SUBJECT: Forwards responses to containment sys independent design review open items transmitted in 810604 ltr to HR Denton.

Subject: Palo Verde Nuclear Generating Station
(PVNGS) Units 1, 2 and 3
Docket Nos. STN-50-528/529/530
File: 81-056-026

RESOLUTIONS OF OPEN ITEMS ADDRESSED AT
CONTAINMENT SYSTEMS IDR

CONTAINMENT SPRAY SYSTEM
FIGURE 2-1

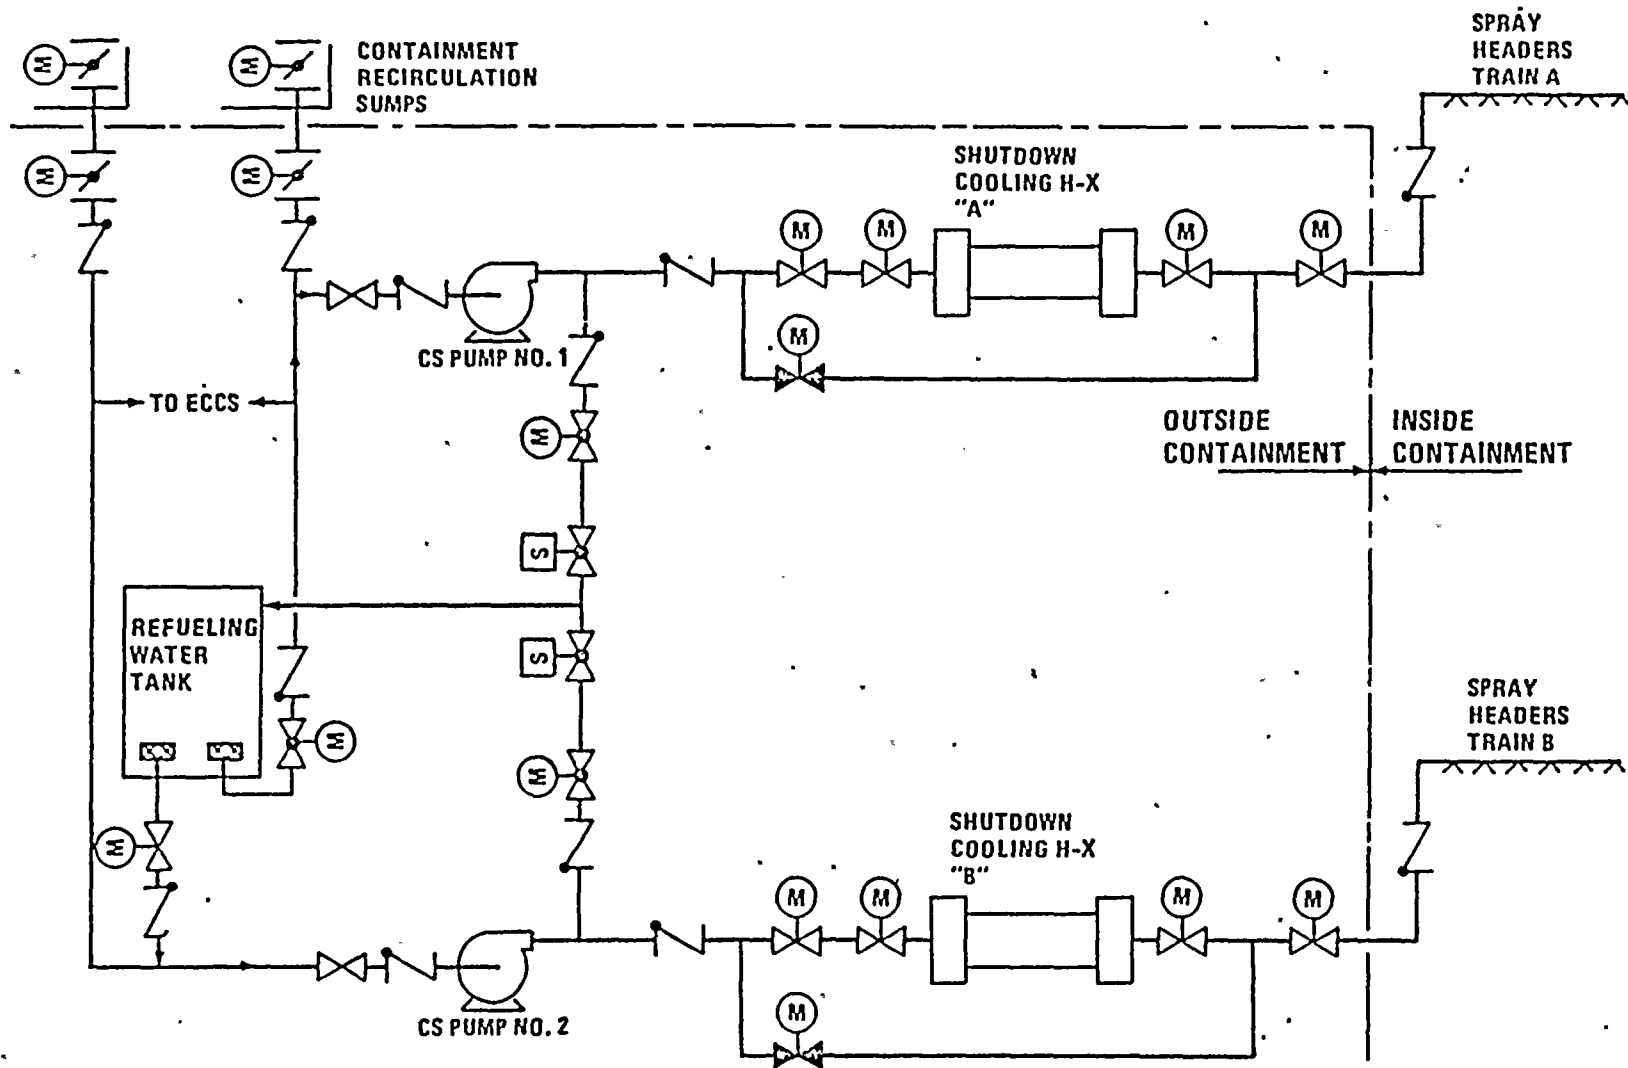
Change Figure 2-1 to include the shutdown heat exchanger bypass line (p. 34).

Figure 2-1 has been revised to show the bypass line and a copy provided for inclusion in the final transcript.

FIGURE 3-7

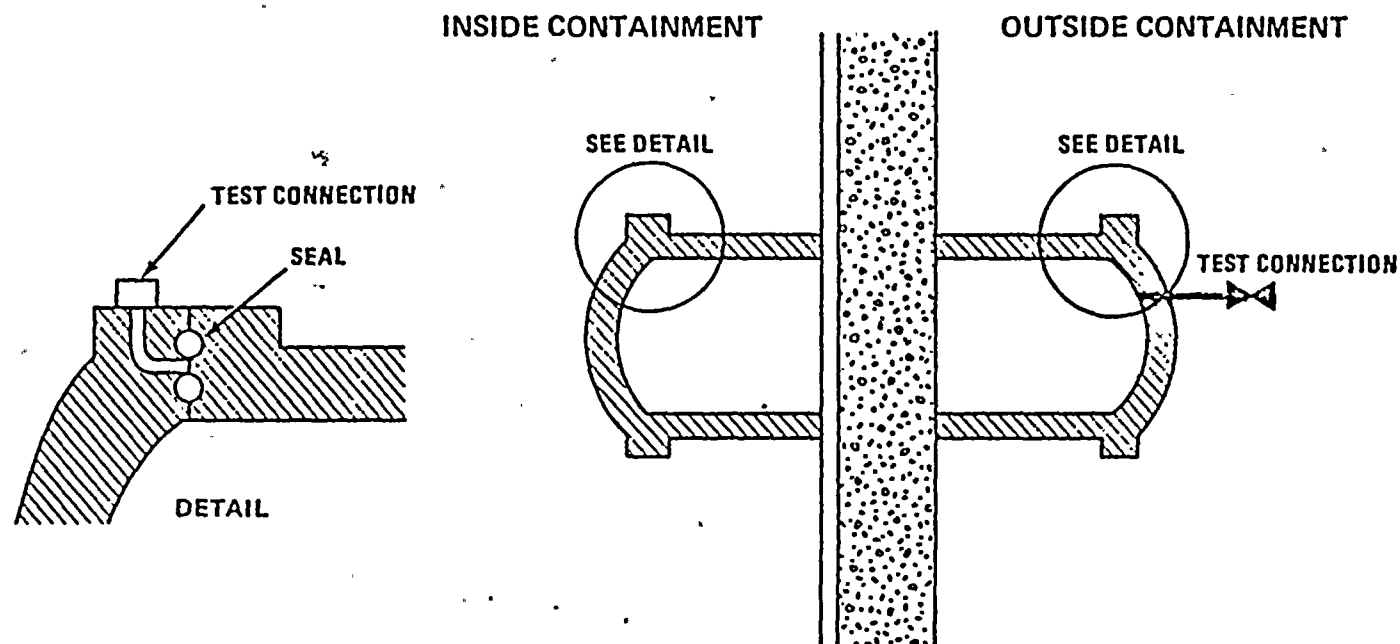
Provide an indication on Figure 3-7 of the type of seal on the outer hatch of the personnel lock (p. 13).

The personnel lock outer hatch is a double "O" ring seal. Figure 3-7 has been revised and a copy provided for inclusion in the final transcript.
